February 25, 2022

RE: Bethlehem Landfill Company (BLC)
Second Environmental Assessment Review
Municipal Waste Major Permit Modification
Application—Northern Realignment
Application# 100020-A203 APS# 1033510,
AUTH ID# 1345418
Response to February 8, 2022 Letter
Our file: b/1162.4/Northern Realignment/RL02082022

SHEET TITLE: **PROPOSED CAPPING SCHEDULE**

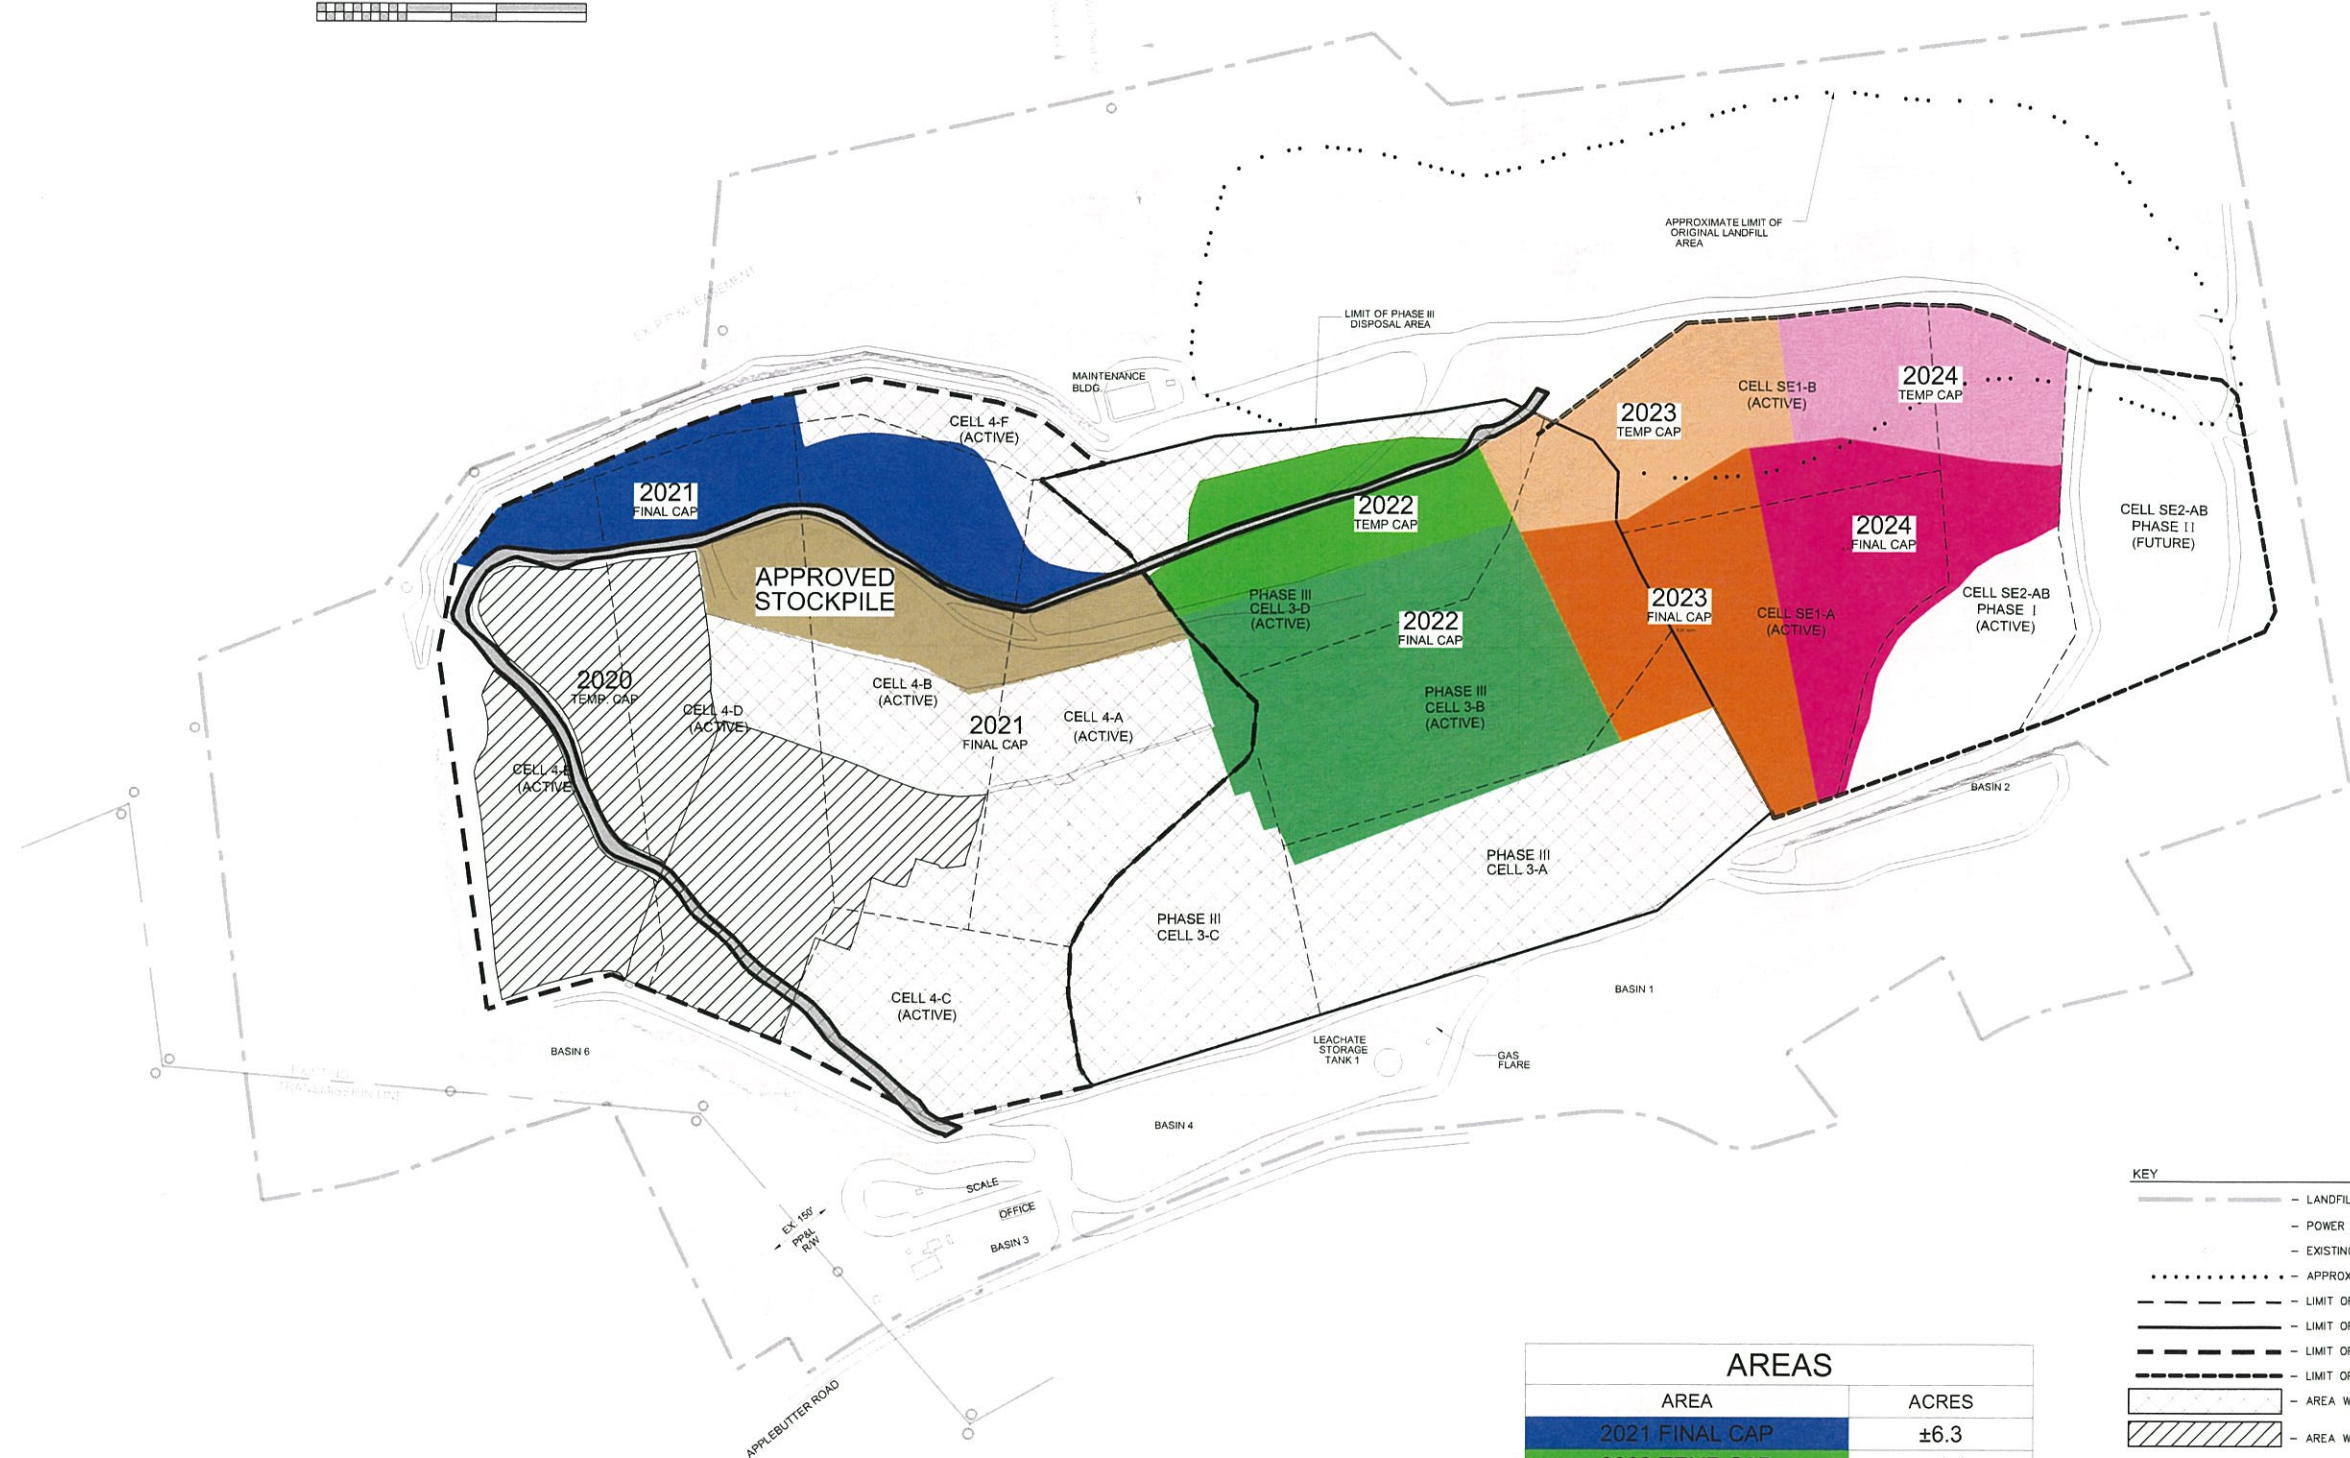
2. Due to an uptick in recent odor complaints, correspondence received by DEP from Lower Saucon Township regarding concerns about odors, observations during DEP inspections conducted since the Department’s first EA letter was sent on September 24, 2021, recent landfill gas surface emission monitoring results, and BLC’s failure to complete geosynthetic capping projects in a timely manner DEP believes BLC should

implement additional mitigation measures to prevent off site odors. Specifically BLC should propose a plan for enhanced surface monitoring to be conducted in areas of intermediate cover and re-evaluate the current final and temporary capping schedules as proposed.

Attached is an updated proposed capping schedule- Attachment B. The +/- 6.3 acres of capping on the North slope that had been planned for the fall of 2021, is scheduled for this spring as soon as weather conditions allow. The 2022 capping projects (+/- 7.7 acres of final cap and +/- 4.1 acres of temporary cap are scheduled to begin in early summer. As previously relayed to PADEP, trucking and material shortages prevented the North slope capping event from getting completed in 2021. Attached is an Enhanced Odor Mitigation Plan- Attachment C which includes performing monthly surface emissions monitoring (SEM) on uncapped areas at intermediate grade with intermediate cover.
